Our Ref: 23485_GRSF_Response to RFI Letter_V02_Final

5 April 2024

RE: Goulburn River Solar Farm - Response to DPHI RFI dated 31 January 2024

FIGURE 2.1

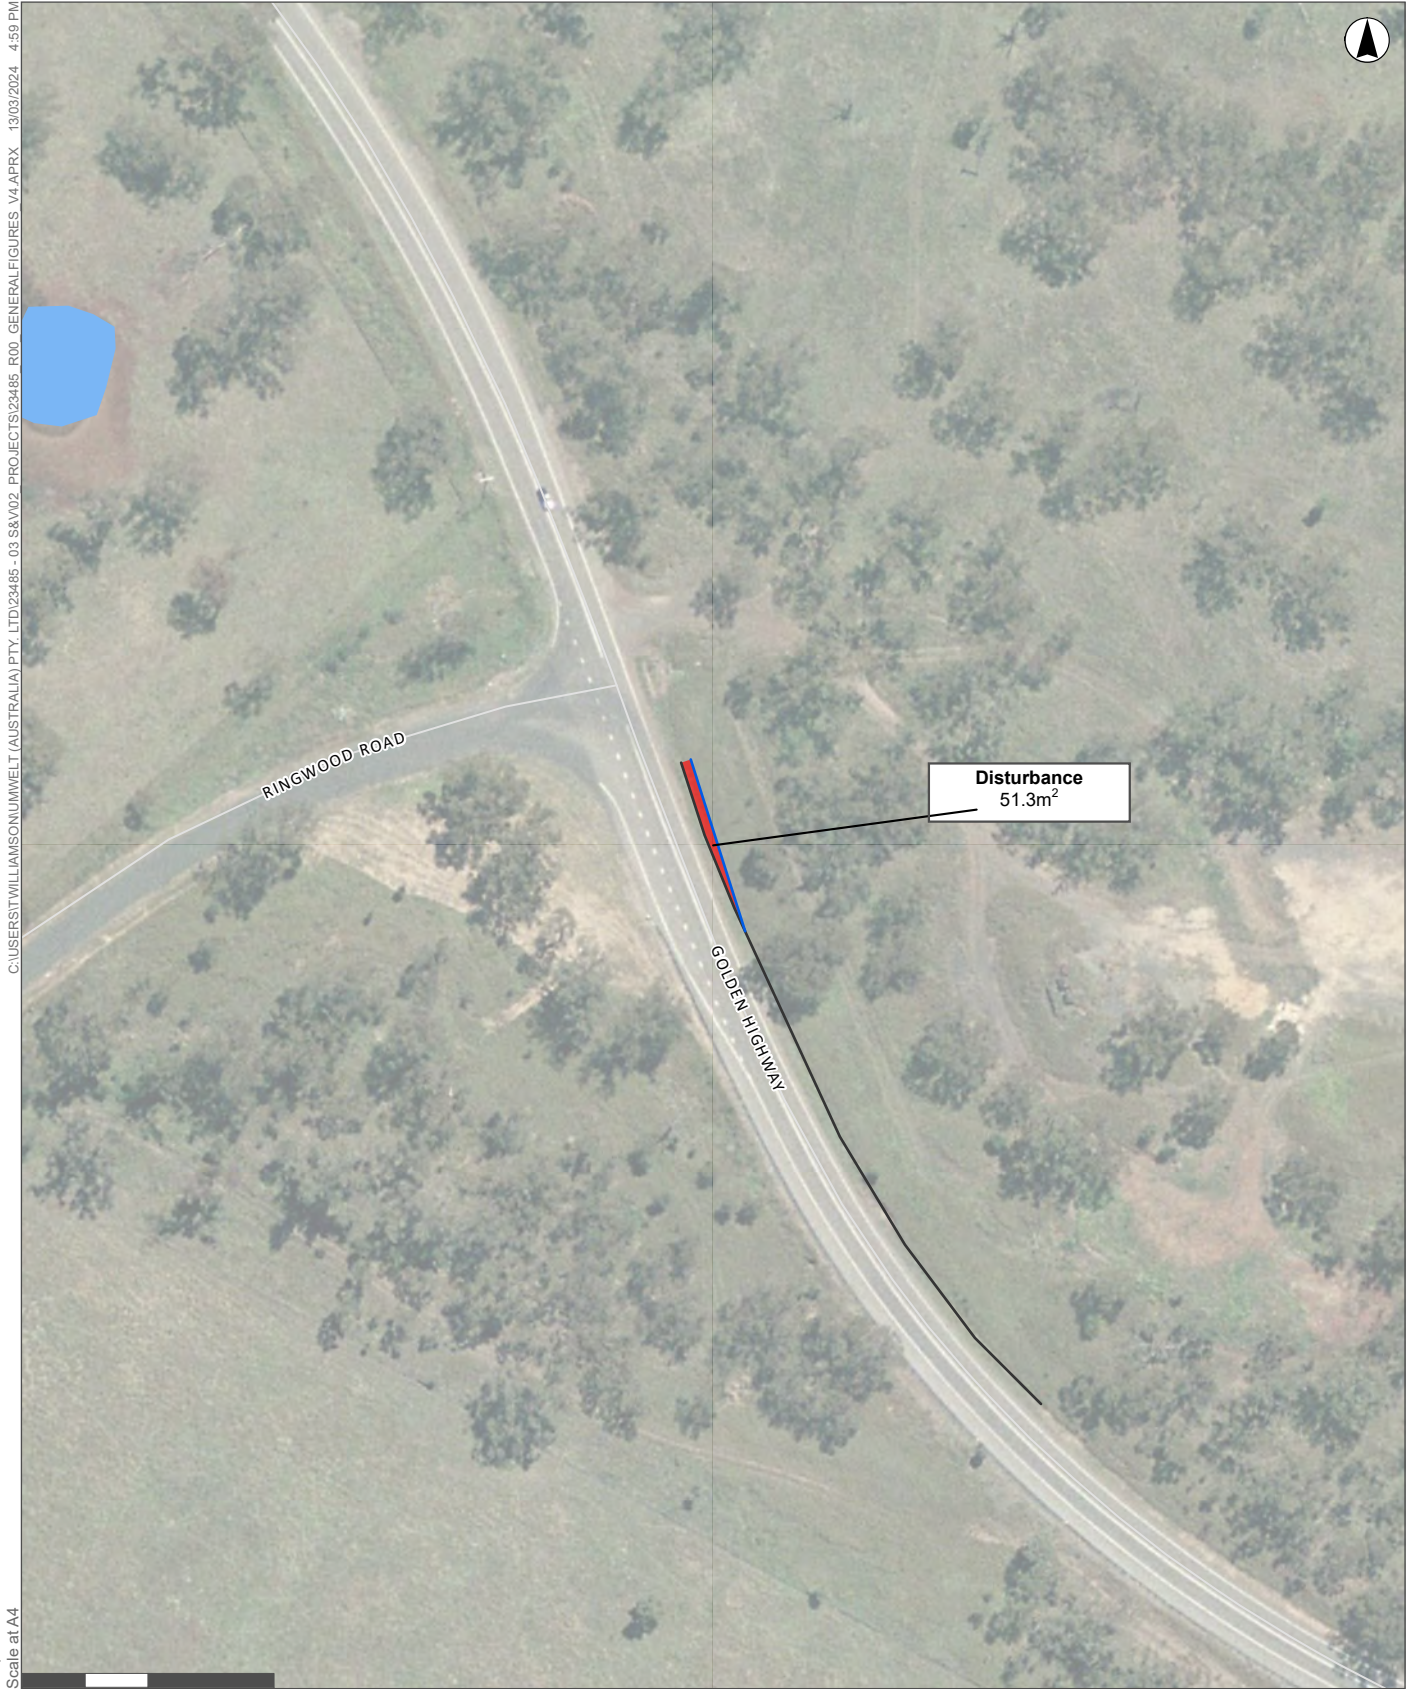
TfNSW also requested the preparation of a Turn Path Assessment for the existing BAR for right turn movements at the Golden Highway onto Ringwood Road. The turn path assessment is included in **Appendix A** of this letter and is summarised below.

The Goulburn River Solar Farm design vehicle (i.e. a 19 m prime mover and semi-trailer) has been assessed as able to utilise the existing BAR facility to bypass a 19 m prime mover and semi-trailer (non-Project related design vehicle). Due to the existing design of the intersection, the design vehicle would however be within the shy line of the barrier and end terminal.

Whilst this meets design requirements, it is not the most optimal outcome with respect to vehicle safety. As such, Lightsource bp are proposing additional works to alter the existing barrier and end terminal currently in place at the intersection, to ultimately improve the safety of road users. Lightsource bp propose to relocate the safety barrier approximately 2 m to the east from the existing starting position, which would continue for approximately 35 m south, lining back up with the existing barrier location. This would provide additional space to allow a vehicle to safely overtake a vehicle waiting to turn right onto Ringwood Road. The alteration of the safety barrier would require an extension of the existing road pavement to the altered barrier, creating a disturbance area of approximately 51.3 m². The location of the proposed safety barrier alteration, and extent of the safety barrier disturbance area, are presented in **Figure 2.1** below.

This area consists of the existing road batter and vegetated table drain. It contains exotic and previously disturbed vegetation as identified during field inspections undertaken to support the Road Upgrades BDAR (Umwelt, 2024b). Canopy trees in the vicinity of the proposed works were predicted to conform to Plant Community Type (PCT) 483 (Grey Box x White Box grassy open woodland on basalt hills in the Merriwa region, upper Hunter Valley), however the alteration of the safety barrier would not impact upon these trees and therefore will not impact on PCT 483. The existing PCTs within the vicinity of the proposed safety barrier alteration works are illustrated in **Figure 2.2**. It is also noted that this area was previously surveyed for Aboriginal and historic heritage significance as part of the EIS Project and was deemed to contain no heritage significance.

As a result of the above, it is concluded that no further biodiversity or heritage assessment would be required to support the alteration of the safety barrier.

Table 5-3: Revised turn warrants assessment (Project only)

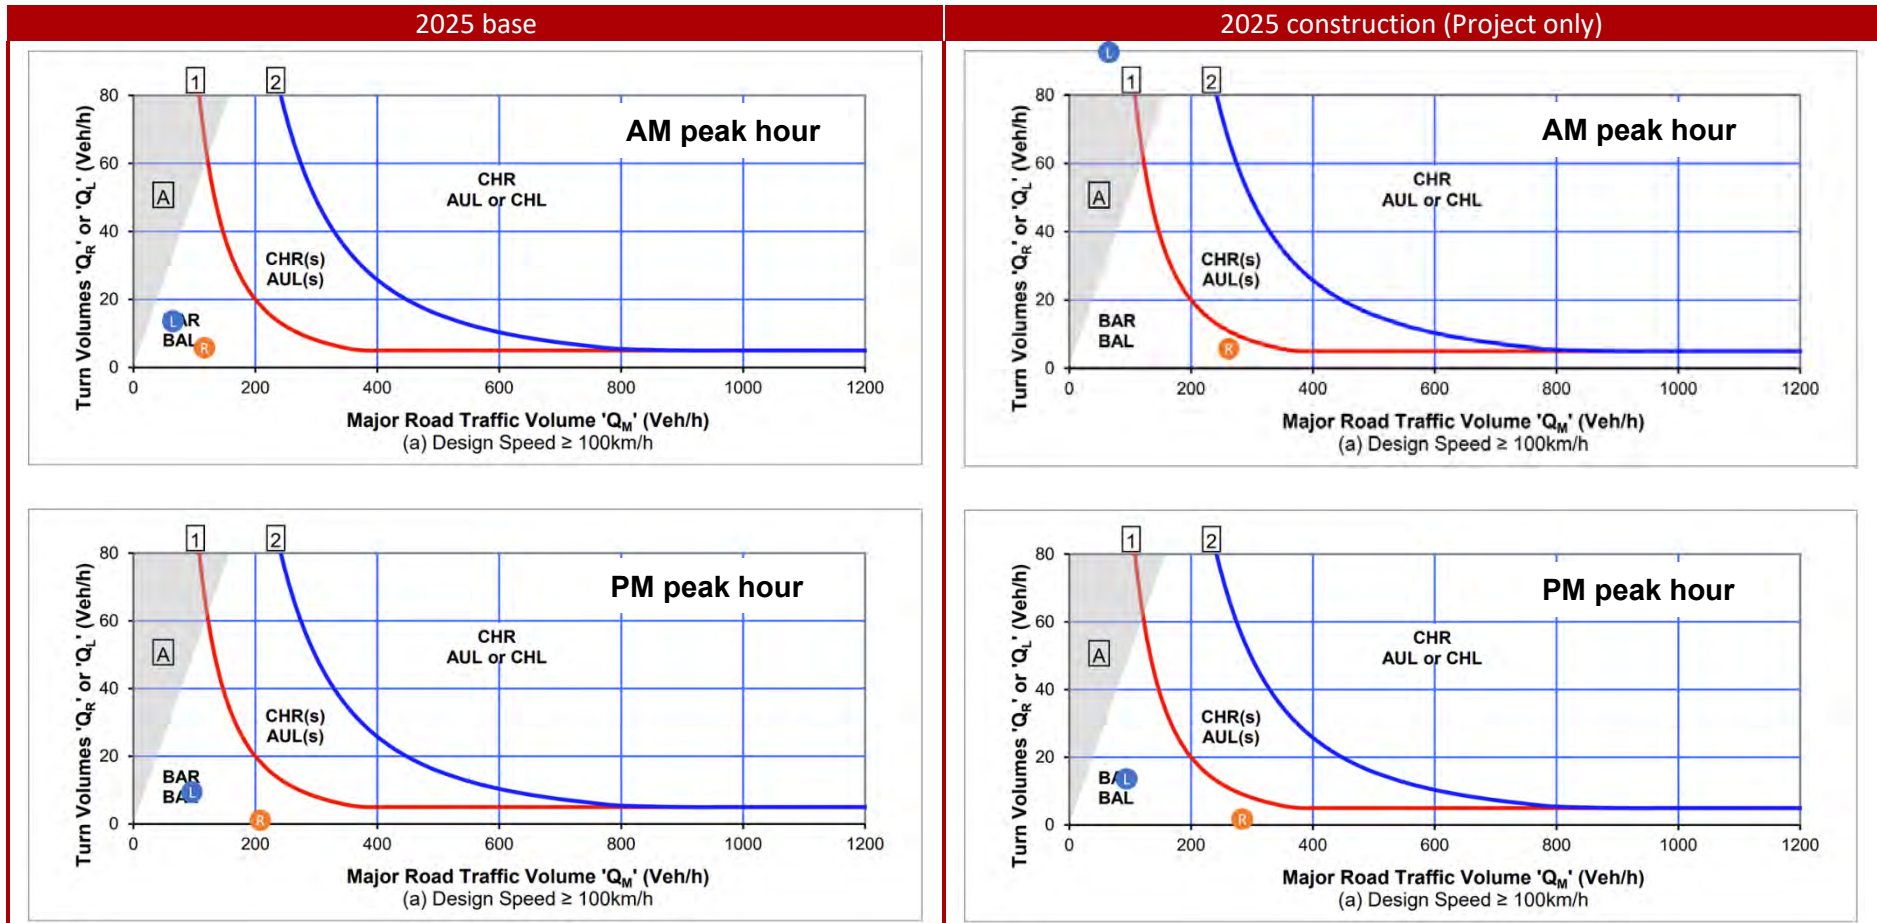
Following an online meeting held on 21 March 2024 attended by Turnbull, Umwelt, Lightsource, TfNSW and DPE, a revised assessment using a reduced background growth rate of 1.6% instead of 2% per annum was requested by TfNSW to determine whether the warrant for a BAR was clearly met. Applying the lower background growth rate had minimal impact on the outcome of the turn warrants assessment as shown below.

As shown in Table 5-3 and Table 5-4, the revised assessment for the right turn with a reduced background traffic growth rate shows that warrant for a BAR vs CHR is still on the threshold as there is a minimal change to the revised volumes.

Table 6-2: Additional turn warrants assessment (non-peak hour)

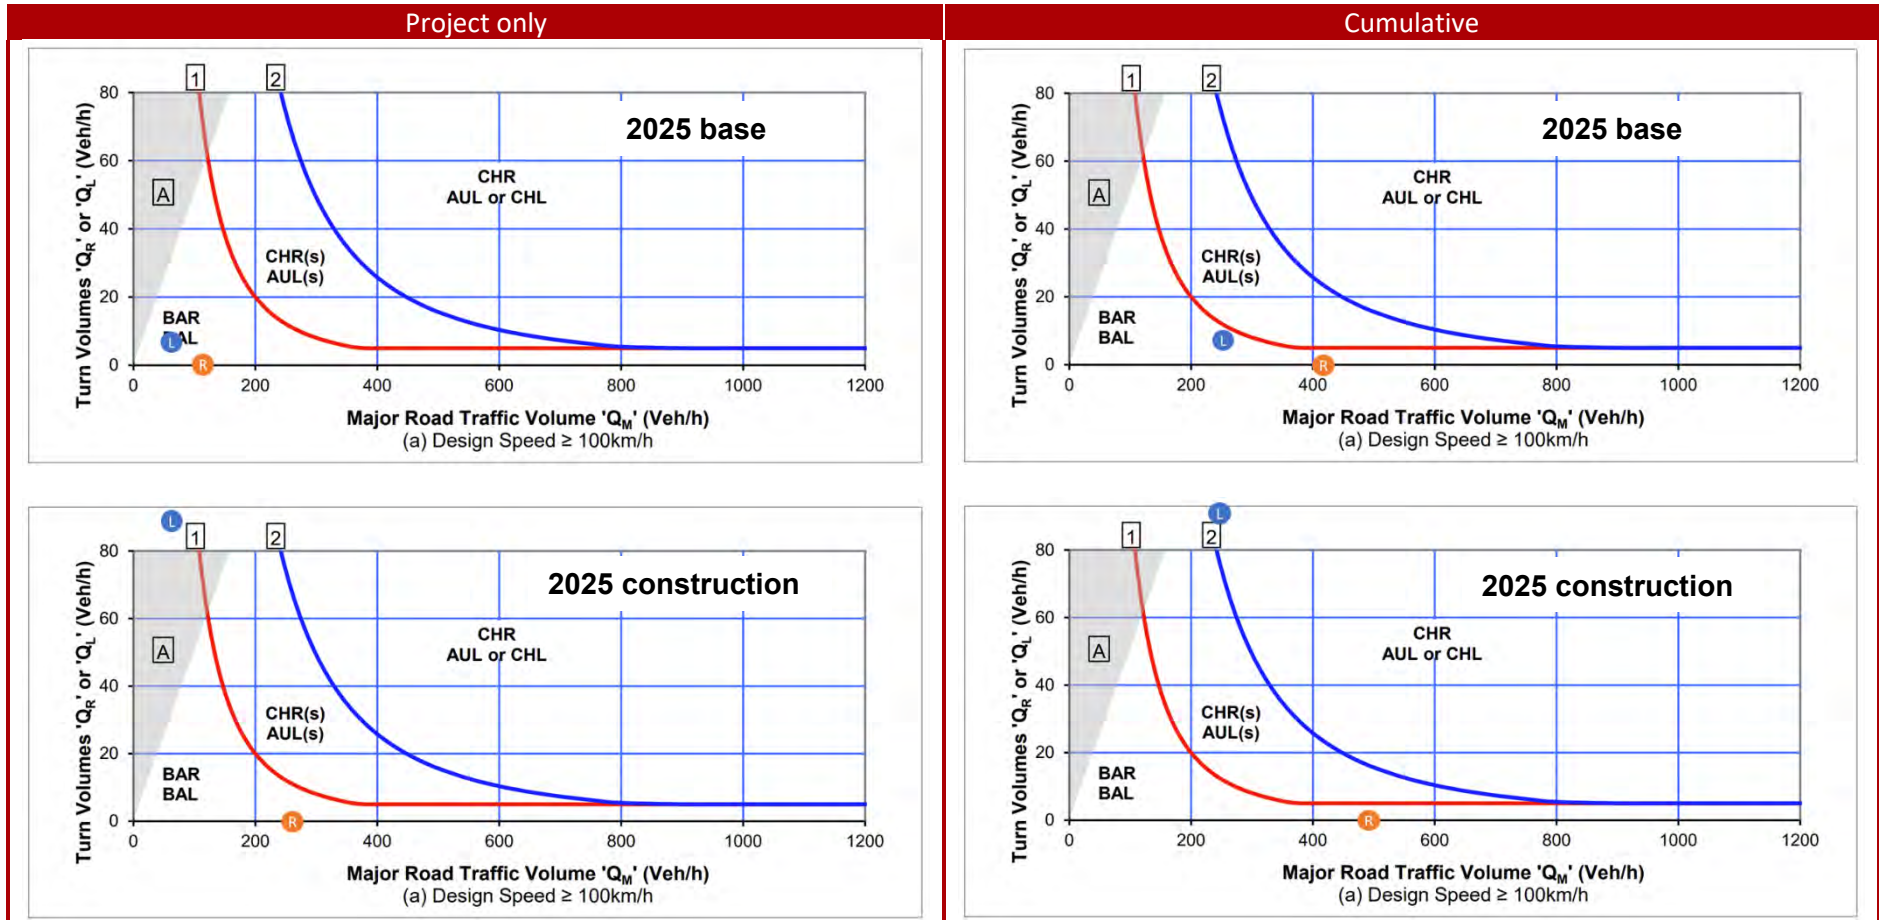
- Revised turn warrants assessment with a lower background traffic growth rate (1.6% per annum)
- Additional turn warrants assessment for a period outside of the road network AM peak hour
- A swept path assessment of the existing BAR.

As shown in Table 6-2, the additional assessment for the right turn with a reduced background traffic growth rate and non-peak hour volumes from 8:30am to 9:30am shows that warrant for a CHR is clearly not met, and the existing BAR treatment would be appropriate.
